## **PLANNING COMMISSION MEETING STAFF REPORT**

**NAME OF PROJECT:** The Homestead Resort

**AGENDA ITEM:** Amendment of 2021 Master Plan

Berg Engineering, agent for The Homestead Group LLC, is proposing to amend the 2021 Homestead Master Plan approved with Resolution 2021-02. The proposal is to amend Exhibit C, which is the open space plan for the resort core. The proposed amendment would adjust open space in the resort core. The total open space acreage would remain unchanged. The proposal would also amend language in Section 13: Access. Current language limits Pine Canyon Road access to maintenance. The proposed amendment would allow maintenance and spa access from Pine Canyon Road. The master plan is on 72.01 acres and is located at 700 North Homestead Drive. The property is zoned Resort Zone (RZ).

OPEN SPACE EXHIBIT IN RESOLUTION 2021-02  
 SECOND AMENDMENT TO THE HOMESTEAD RENOVATION AND EXPANSION MASTER PLAN DEVELOPMENT AGREEMENT

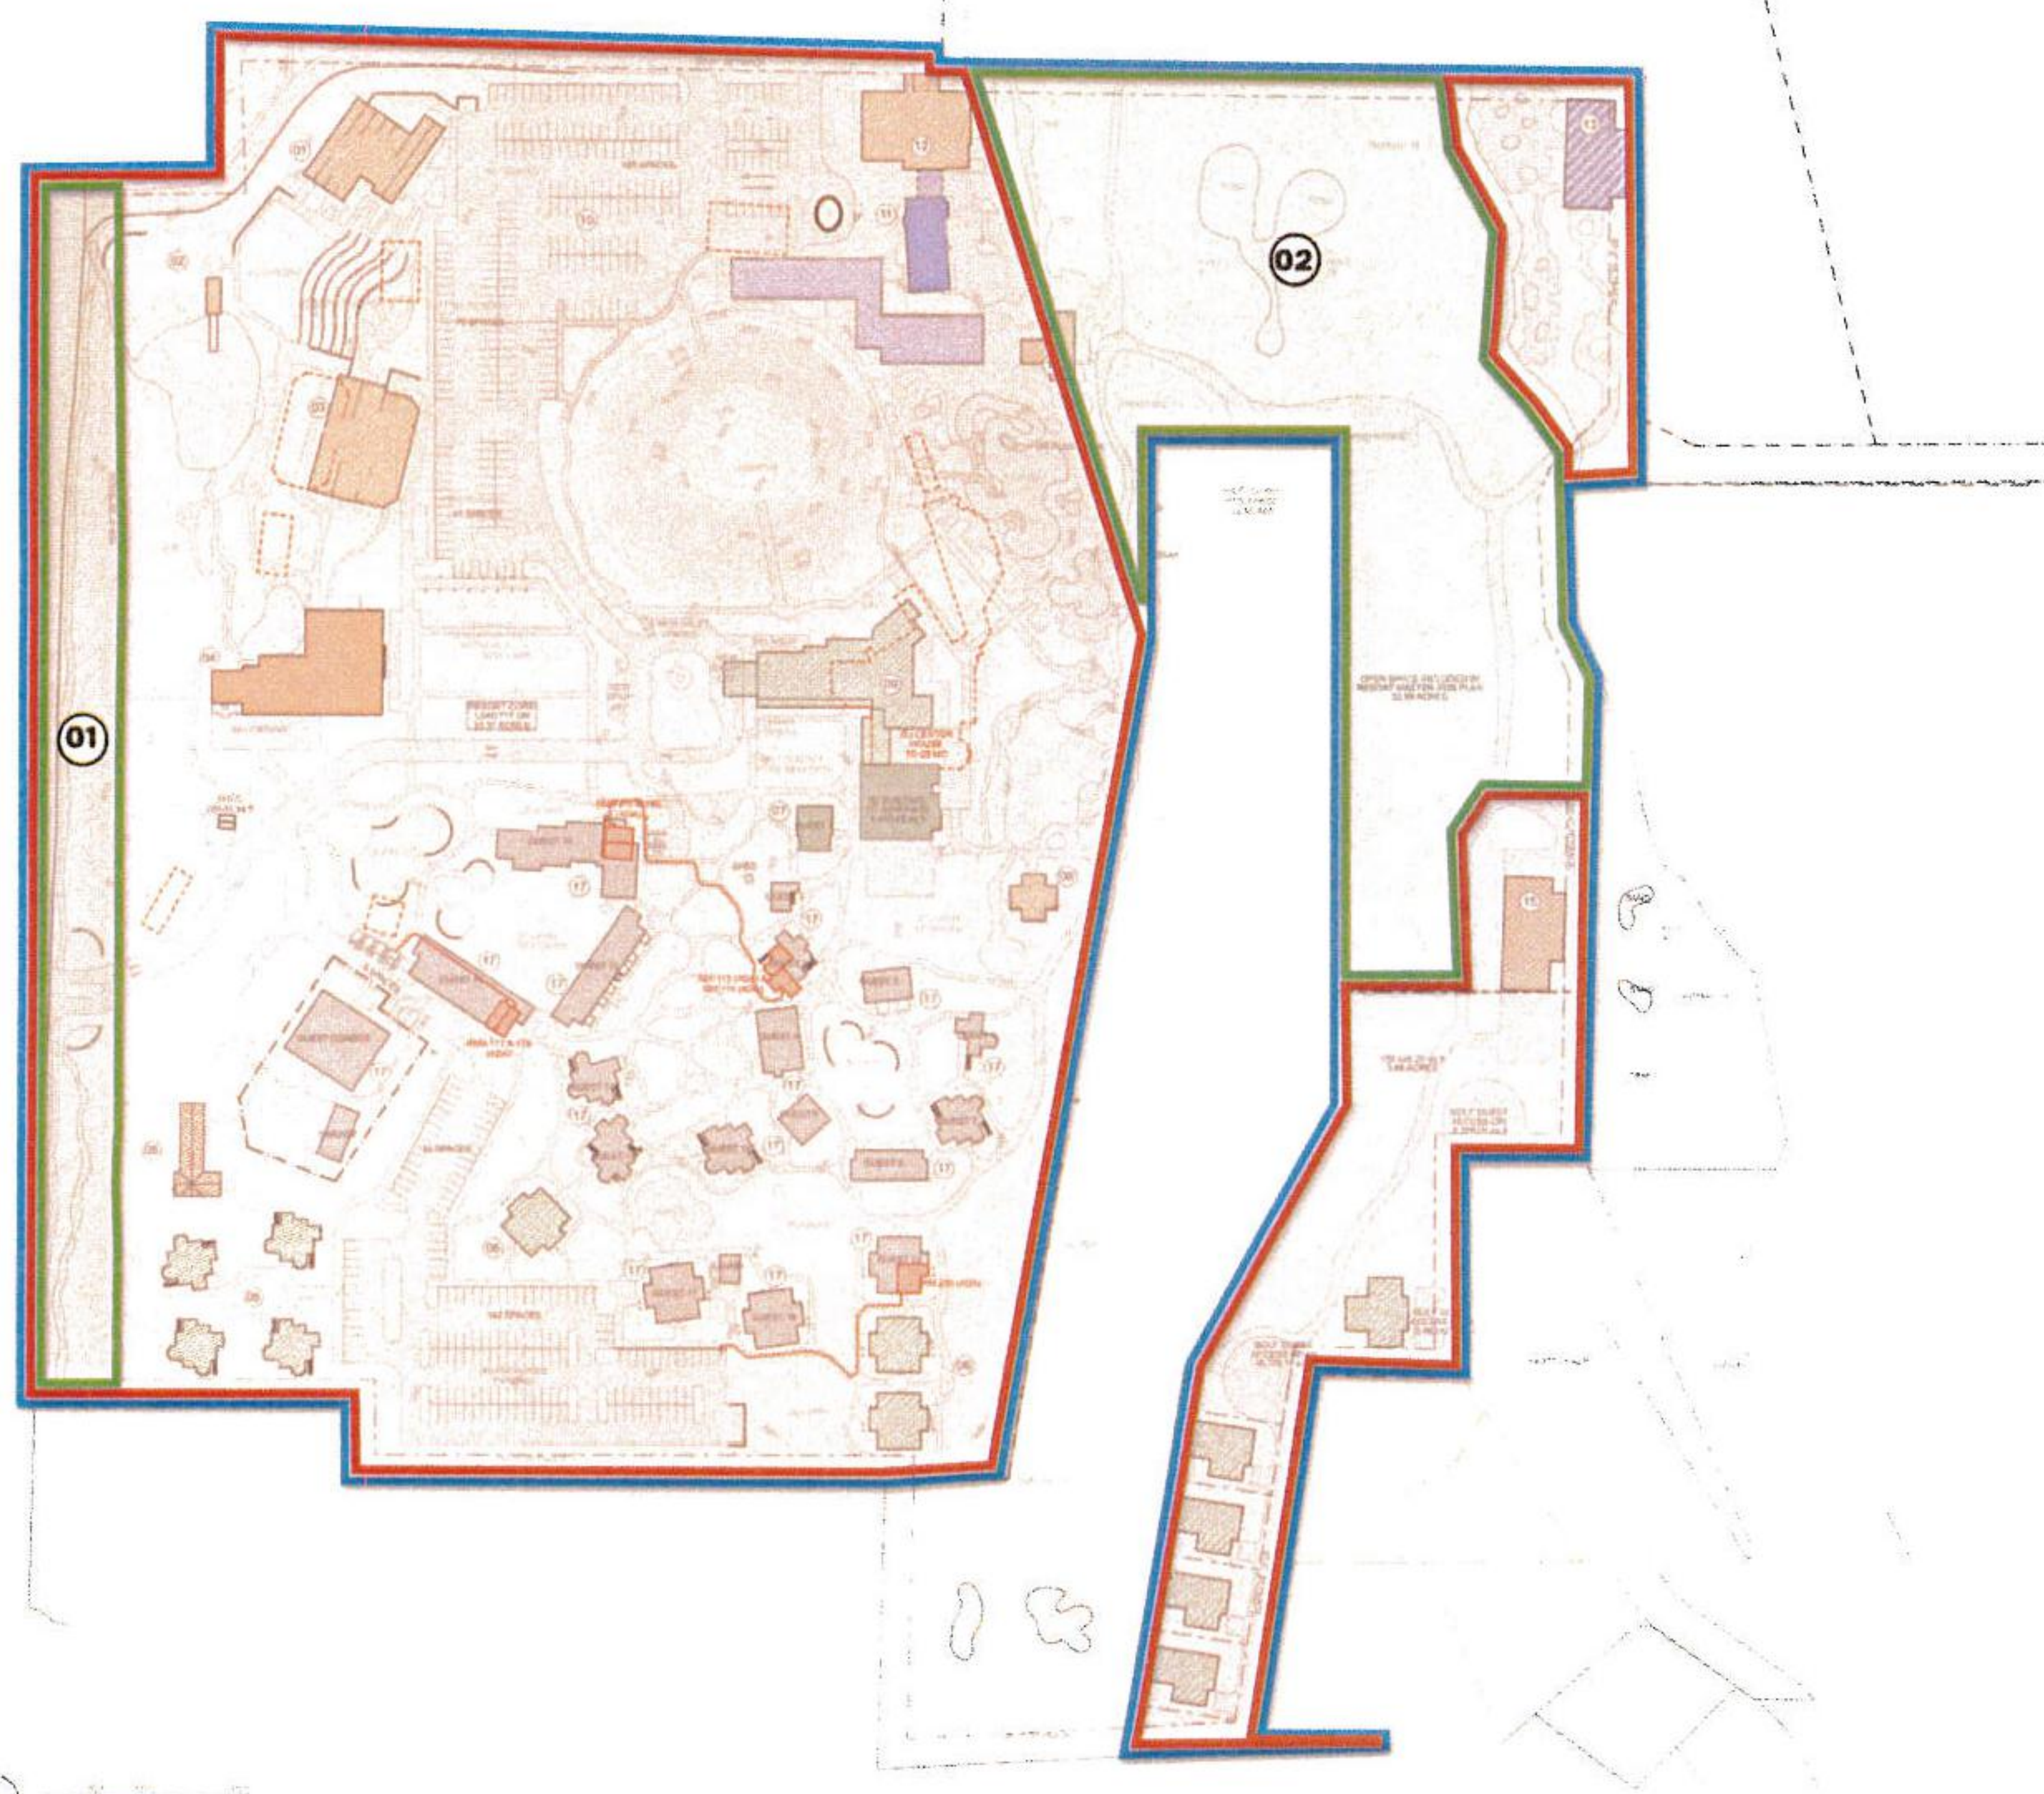
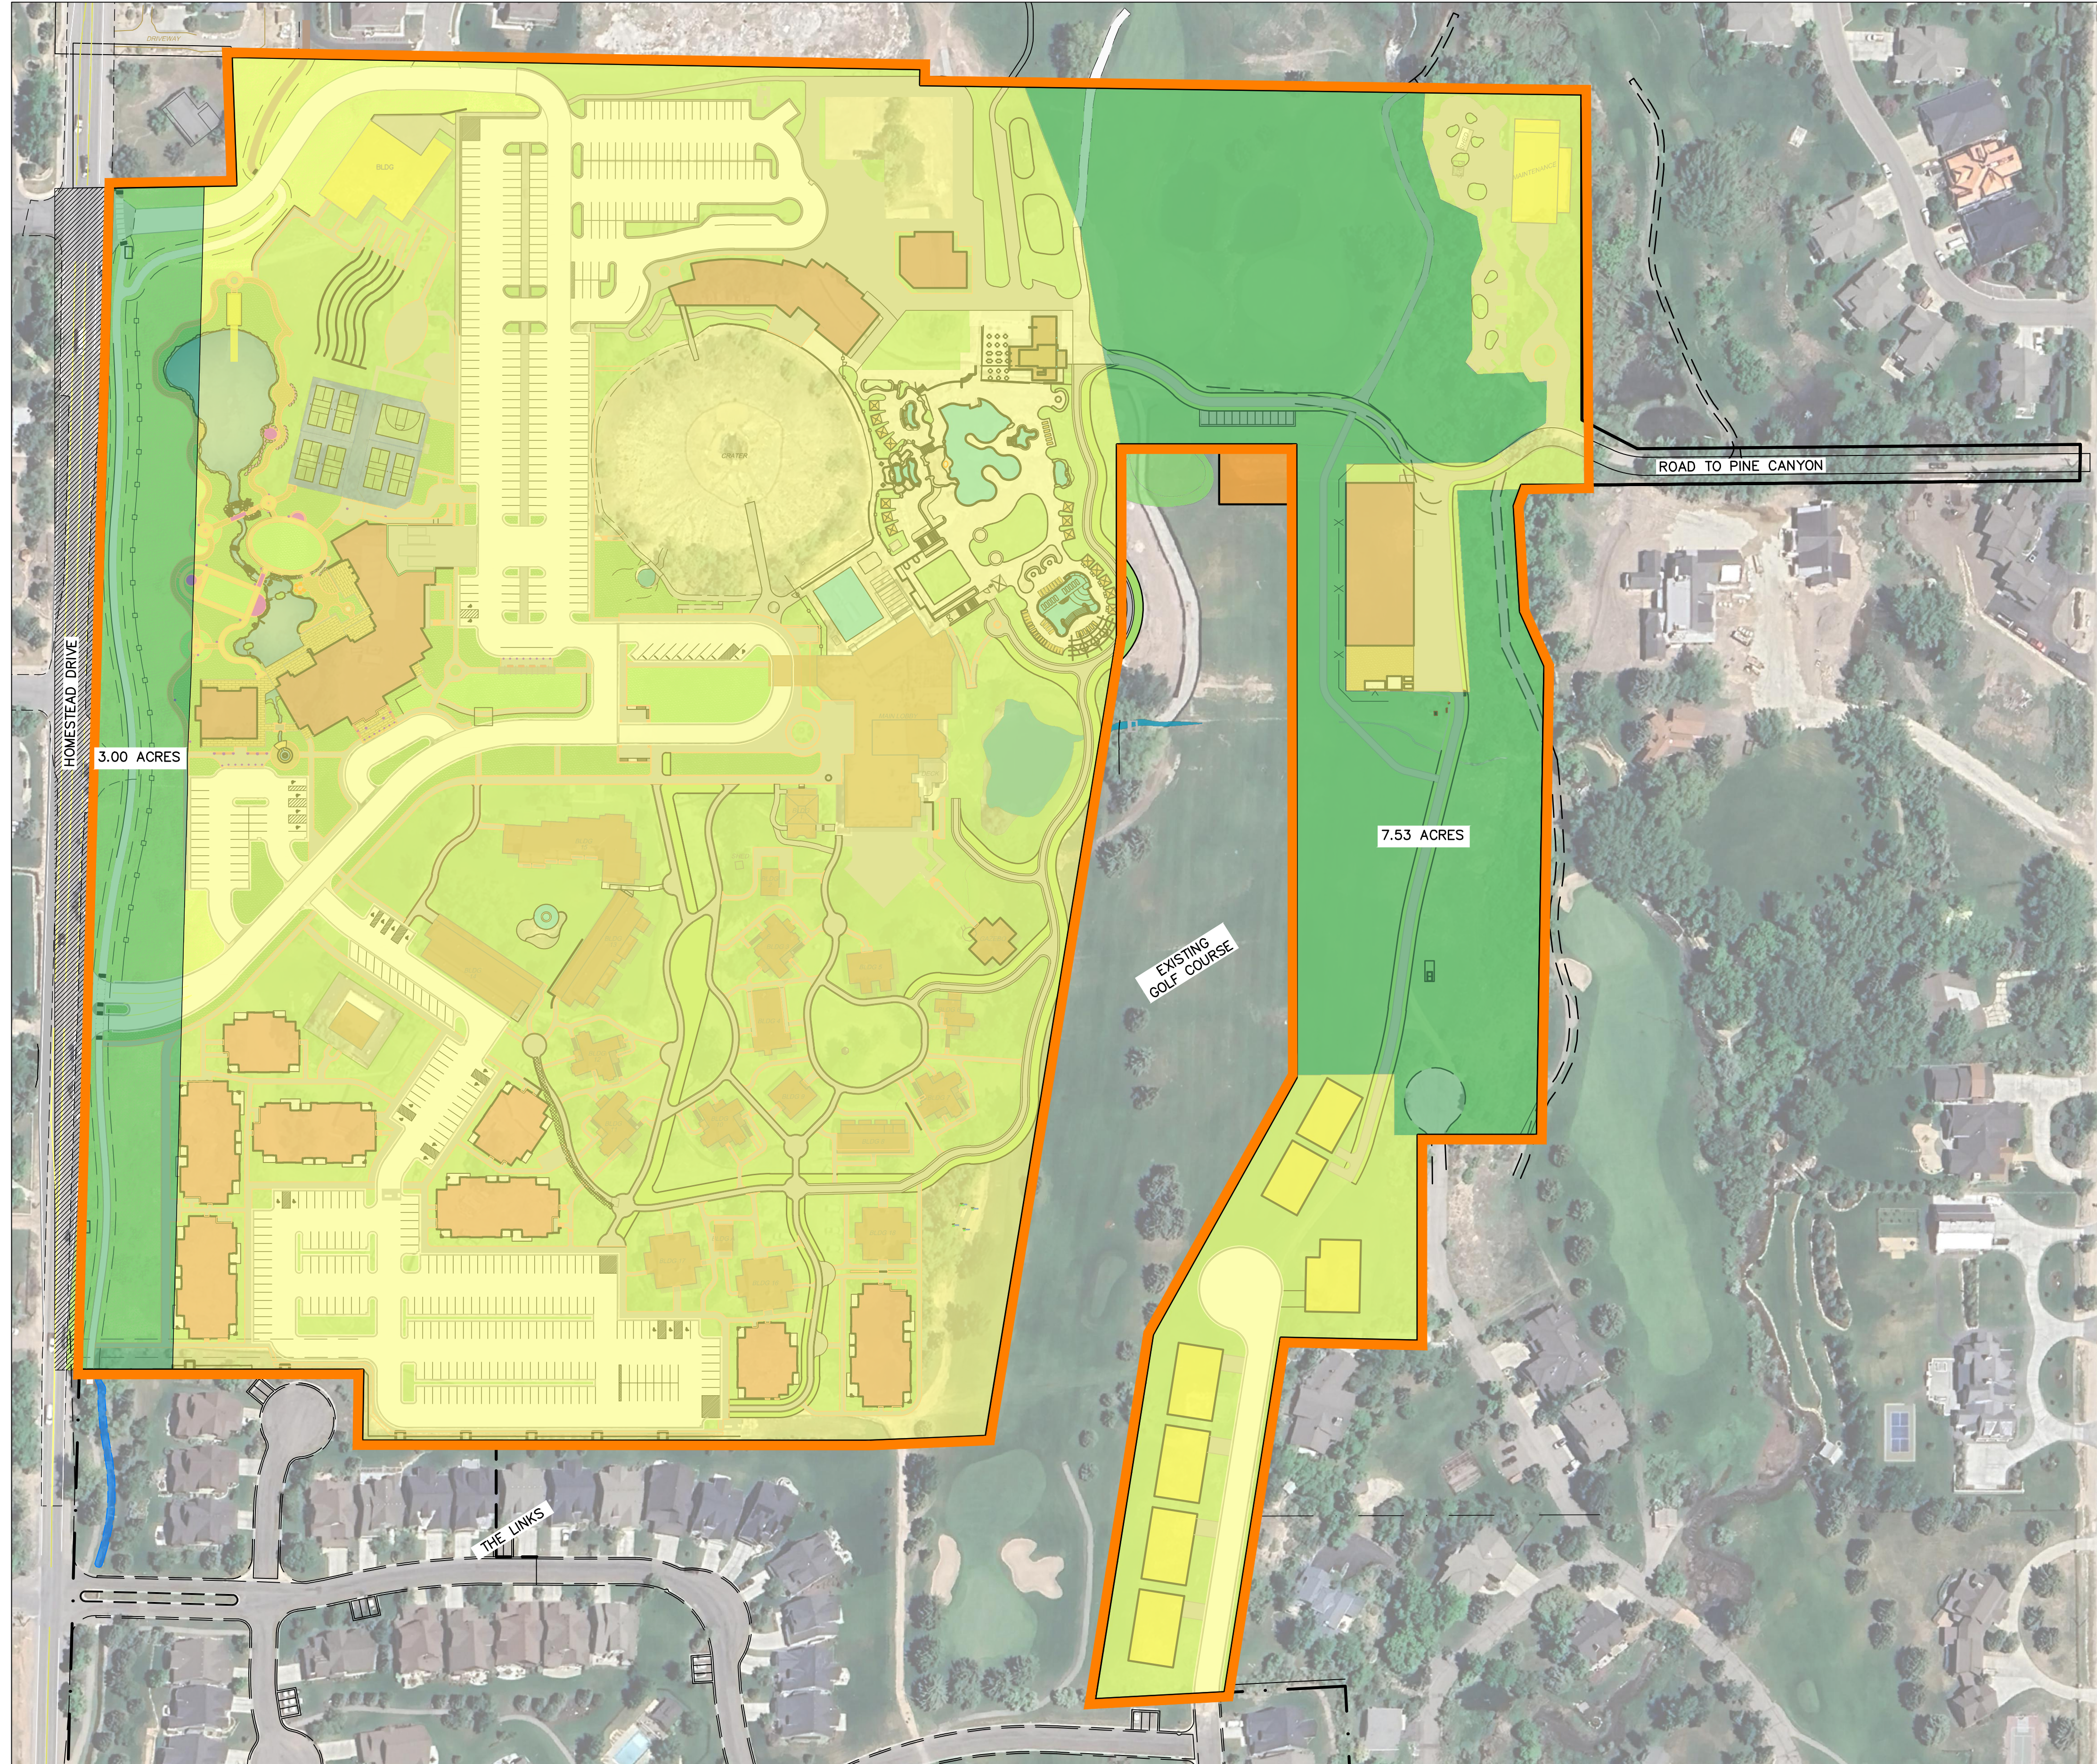
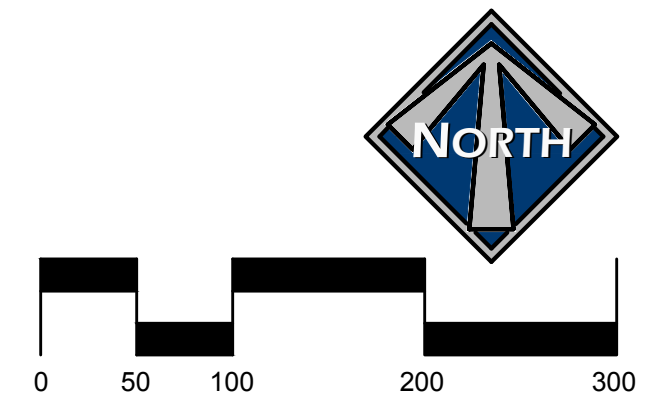
The proposed amendment to Exhibit C will adjust the location of, but not reduce, open space in the resort core. The purpose of this amendment is to move the location of the proposed maintenance building to an area that, according to the applicant, is less visible from neighboring properties and to resort guests. The resort core open space is 10.53 acres, and the proposed amendment would leave the acreage unchanged. The applicant states the following in the application:

*This is a minor amendment to an Exhibit C – Resort Open Space in 2021 amendment. The maintenance building is proposed to be relocated into an area that will be less visible to neighbors and to resort guests. A swap of open space and resort developable area is needed for the new location. The total open space in the resort core remains 10.53 acres.*

REVISED CORE OPEN SPACE  
 AND BUILDING AREA 2025
